MEETING NOTICE AND AGENDA
TECHNICAL ADVISORY COMMITTEE
OF THE
SEASIDE BASIN WATER MASTER

DATE: Wednesday, November 18, 2015

**Seaside Groundwater Basin Watermaster
Technical Advisory Committee Meeting
September 9, 2015**

Comparison of Boundaries for the Seaside Groundwater Basin

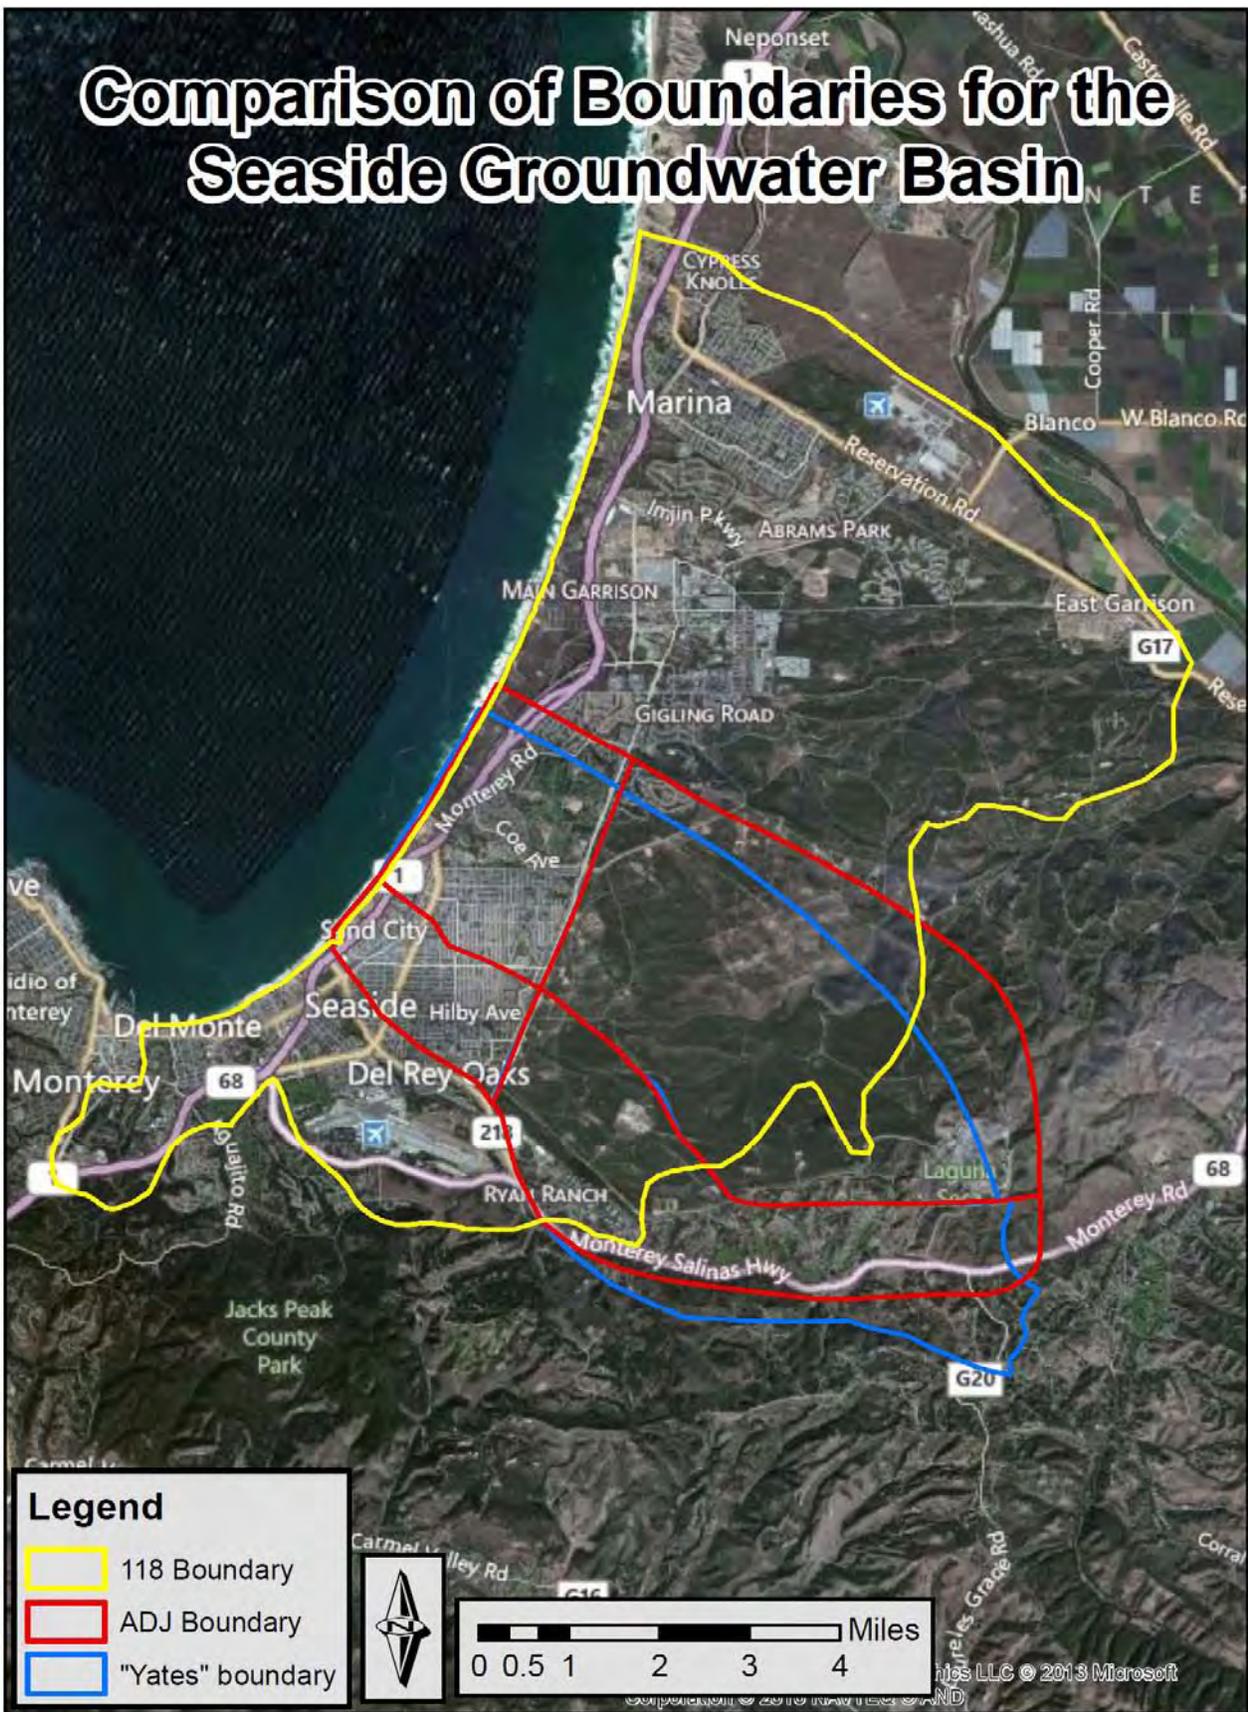
AGENDA ITEM:	2.D (Continued)
<p>DWR’s website regarding the SGMA I found that they have incorrectly shown the entire Seaside Subbasin (of the larger Salinas Valley Basin) as being adjudicated. I sent them a map Joe Oliver had prepared that showed the Seaside Subbasin boundary, as contained in DWR Bulletin 118, and the Adjudication Decision boundary and asked DWR to correct their map to show that the Seaside Basin Adjudication Decision only applies to a portion of the Seaside Subbasin. Attached is a copy of the DWR website’s map and also the one prepared by Mr. Oliver. DWR responded saying that they will correct their mapping to properly show the Adjudication boundary location.</p> <p><u>Regulations for Requesting Boundary Changes:</u> DWR has recently adopted its regulations to revise basin boundaries from those currently shown in their Bulletin 118 and will initially accept requests for boundary revisions for a 90 day period beginning on January 1, 2016. They indicate that they will have additional submittal periods which they will provide notice of, but do not indicate how long into the future it may be after the initial submittal period before they open up another submittal period. Attached are DWR’s regulations which require considerable supporting documentation, coordination with other potentially affected agencies, public review, and CEQA compliance, among other things. Thus, if any entity wished to request a boundary revision this complex process would need to be carried out rapidly.</p> <p>According to Russ McGlothlin the Watermaster would not qualify to submit a boundary revision request, even if it wished to, as it is not a “local agency” as defined by Water Code Section 10721(m) (which is SGMA Section 10721(m). He reports that DWR is taking a strict line on this. However, he said that any of the cities or the MPWMD could do so.</p> <p>At this point it is not known whether the Watermaster would want to seek a boundary revision, which according to Mr. McGlothlin would have to be submitted by another entity. If the Watermaster did wish to seek a boundary revision it would probably be best to try to coordinate that with MCWRA or MPWMD.</p>
